State of Utah
DEPARTMENT OF NATURAL RESOURCES
DIVISION OF OIL, GAS AND MINING

RE:

Site Inspection, Interstate Brick Company, Big Cottonwood Mine, M/035/003,

Purpose of Inspection: To oversee reclamation activities

Berm before improvement

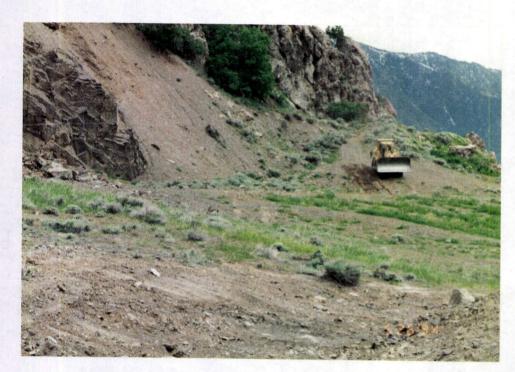
Material for the berm improvement came from the upper pit floor. Soil was stripped from the area east of the berm and pushed onto and over the existing berm. This created a ditch east of the berm that will help in catching any material that might fall from the highwall. Pictures were taken before and after berm improvement.

When we returned in the afternoon, we measured the new berm length to be 235 feet. The new berm height was built up to about seven or eight feet above the upper pit floor. The berm outslopes were built in accordance with the approved plan. Areas of compaction had been ripped.
